Design Note

Project Begbroke Innovation District
Subject Buro Happold's Response to LLFA Interim Consultation
Project no 0052188
Date 26 October 2023

Figure 2-1 Overall site proposed drainage catchments (Figure 5-3 from ODS). (Note: Arrows represent indicative flow directions)

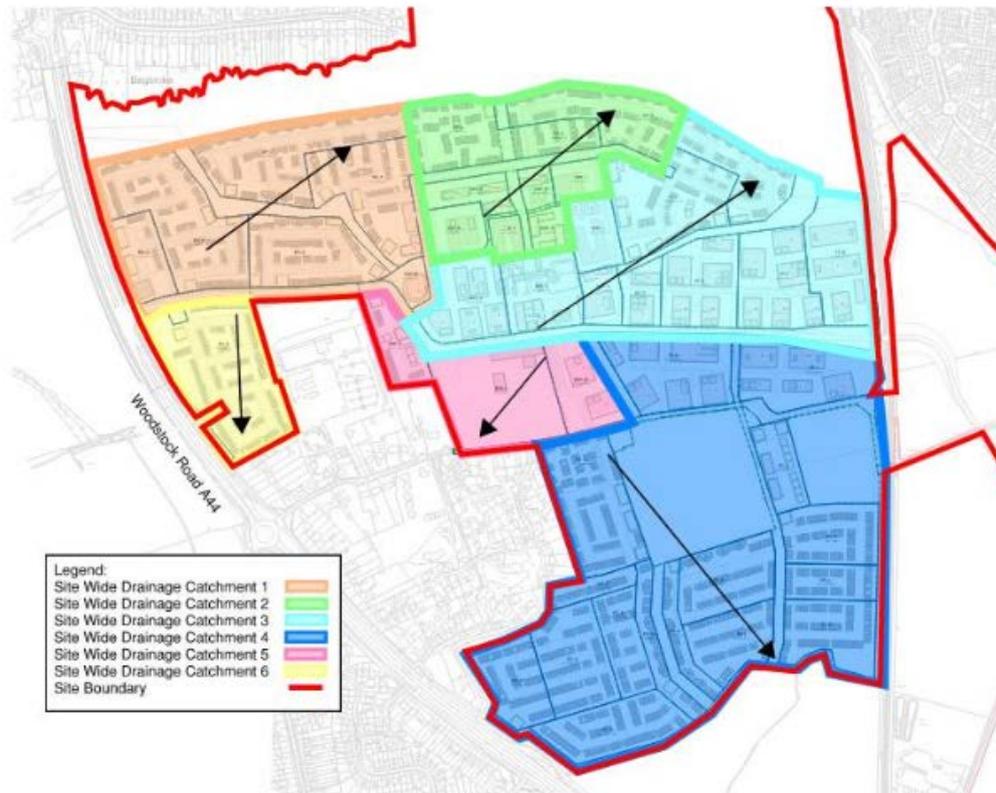
LLFA Comment 1: Table 2-5 refers to existing catchments and their proposed outfalls, it's unclear where these catchments are as they are not shown on plan. Provide surface water catchment plan stating the catchments and the locations of the outfalls and discharge rates.

Buro Happold (BH) assumes this is an erroneous reference to Table 5-2 (there is no Table 2-5). Table 1 below (Table 5-2 in ODS) provides the existing greenfield run-off rates for multiple storm event scenarios as well as the QBAR rate. These are for the proposed site drainage catchments shown in Figure 2-1.

The proposed points of discharge are provided in Table 1 below (Table 5-2 in ODS). These are via infiltration and/ or watercourses. An illustrative site wide drainage layout is provided in Figure 5-4 of the ODS. The number and location of these points of discharge will be confirmed through later stages of design and planning as the masterplan is developed.

The proposed strategy aims to respect the existing catchments and attenuate surface water close to its source before discharging into the ground and/or to the three local watercourses. The discharge locations, discharge rates and attenuation volumes will be confirmed during the later stages of design and planning. An indicative assessment has been provided in section 5.4 of the ODS.

Figure 2-3 Baseline Fluvial Modelling Results with illustrative masterplan overlaid for the 1 in 100 year + 41% CC and the 1 in 1000 year flood extents (Extracted from Figure 17 of the Flood Risk Assessment)

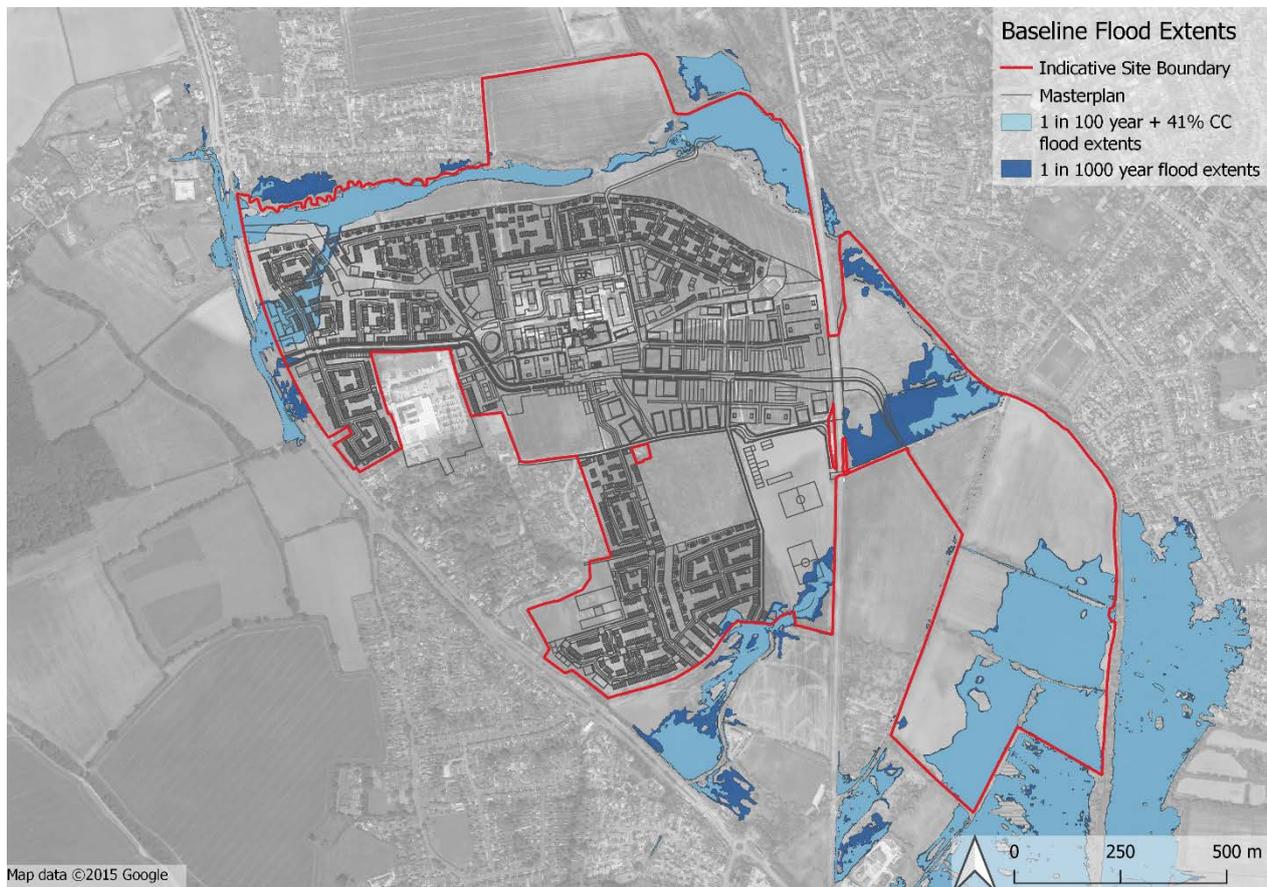
LLFA Comment 2: The yellow catchment along Woodstock Road is shown to discharge to the same outfall, which is currently facing flooding issues, this is the same outfall as PR9. Clarification is required on the exact outfall location as its not shown on plan.

Section 4.1 of the Flood Risk Assessment identifies an offsite overland flow route from the PR9 site which flows over the A44 and across the north west corner of the site as shown in Figure 2-3 below. To mitigate the flood risk to the masterplan in this location, a swale is proposed within the site boundary along Woodstock Road which will act to re-route the flood water along this designated corridor before overtopping and flowing north into the Rowel Brook. This is an additional measure to those proposed in the surface water drainage strategy. Further details are provided in section 4.1.1 of the FRA.
